RE: Zoning Challenge
5 West 13th Street
Block 577, Lot 34
DOB Job Number: M01164499

At the request of a neighbor, our office has examined the accepted ZD1 for the proposed building at 5 West 13th Street (also known as 8 West 14th Street.) We are challenging both its zoning approval and ZD1 itself, based on DOB procedures and the Zoning Resolution.

Summary of challenged items

Figure 1: Axonometric view of the proposed building created by my office using traditional land use colors.

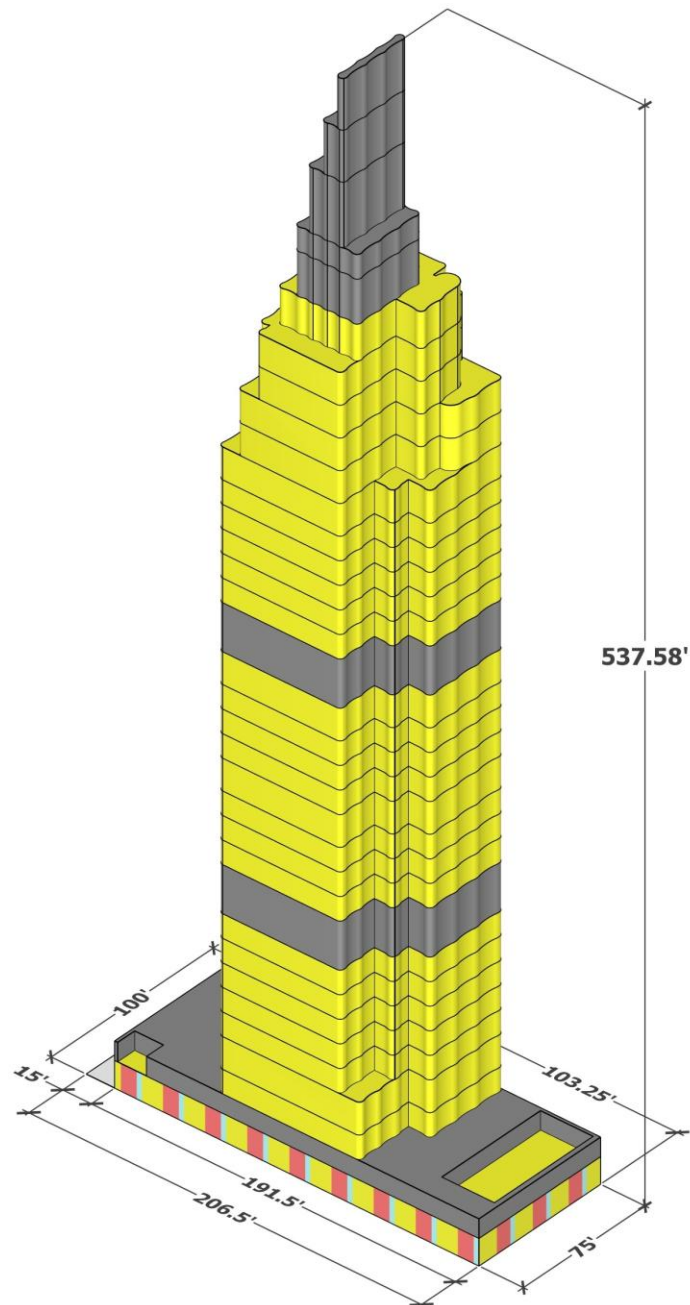
The ground floor is shown using multiple colors because the ZD1 does not show where the different uses are located.

Figure 2: Detail of an axonometric view found on the ZD1.

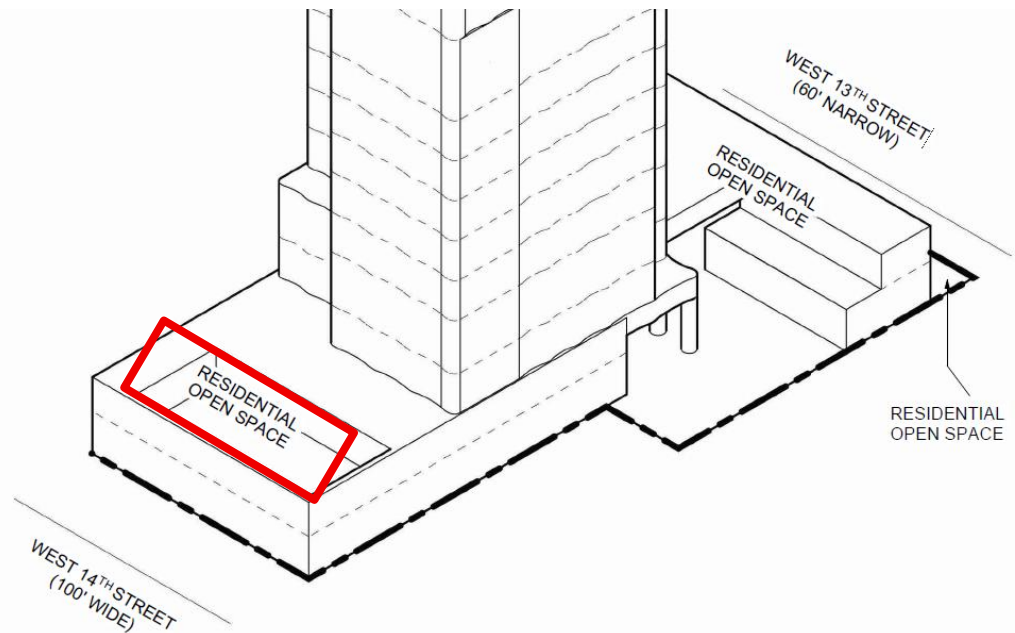
While the ZD1 lacks much of the detail necessary to critically evaluate their assumptions, the floor area table shows zero zoning floor area on the second floor. This is clearly wrong, as the ZD1 shows that there is zoning floor area on the

second floor. The following is a detail of “NW AXONOMETRIC DIAGRAM A” from the ZD1:

The area marked in red above with the label RESIDENTIAL OPEN SPACE appears to be a space on the roof of the first floor. It is enclosed on all sides by walls that form the second floor and has no roof. As you know, floor space enclosed by walls is zoning floor area under ZR 12-10. The fact that it has no roof does not matter for the purposes of defining zoning floor area. The proposed building completely builds out its residential floor area, and so any additional floor area added from this area will push this building out of compliance. Of course, as stated in Item 1, the building as designed is clearly not permitted, but if it were, it would be too large because this space would count as floor area.

Figure 3: The only site plan found on the ZDI. It shows exactly one dimension.

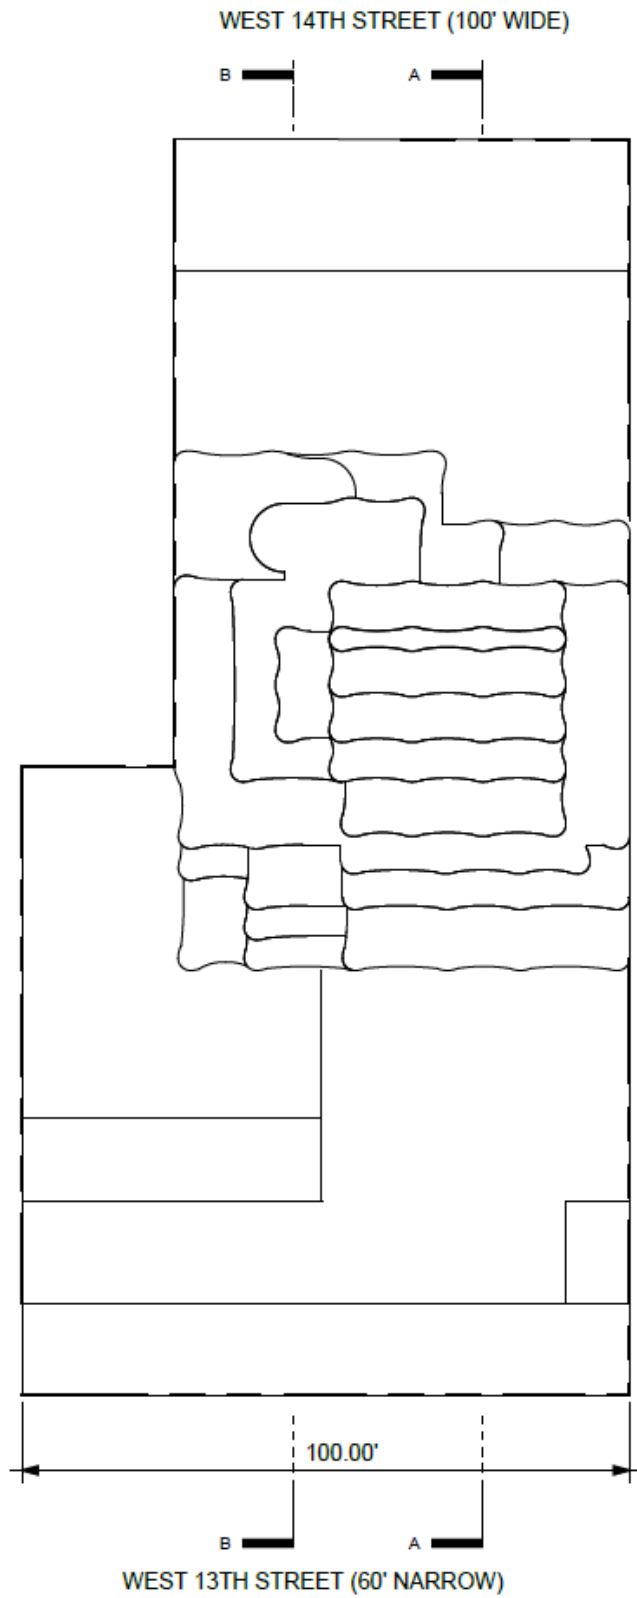
Most obviously, only one dimension is shown: the width of the lot on 13th Street. The ZD1 guide instructs that all lot dimensions and building dimensions should be shown. Further, the Zoning Diagram Guide instructs users to provide basic zoning measures that have simply been omitted. The following is captured from page 3 of the Zoning Diagram Guide:

In addition to a site plan with almost no information, there is nothing regarding lot coverage, lot area, street trees, or yards. The plan shows that onsite parking will be provided. Where is the detail on the curb cuts and splays, as required by the Zoning Diagram Guide? There is no zoning district identified. This missing information is especially material because the job is still in objections and full building plans are not available. The only information accessible to the public showing the applicant's intent is this woefully incomplete ZD1.
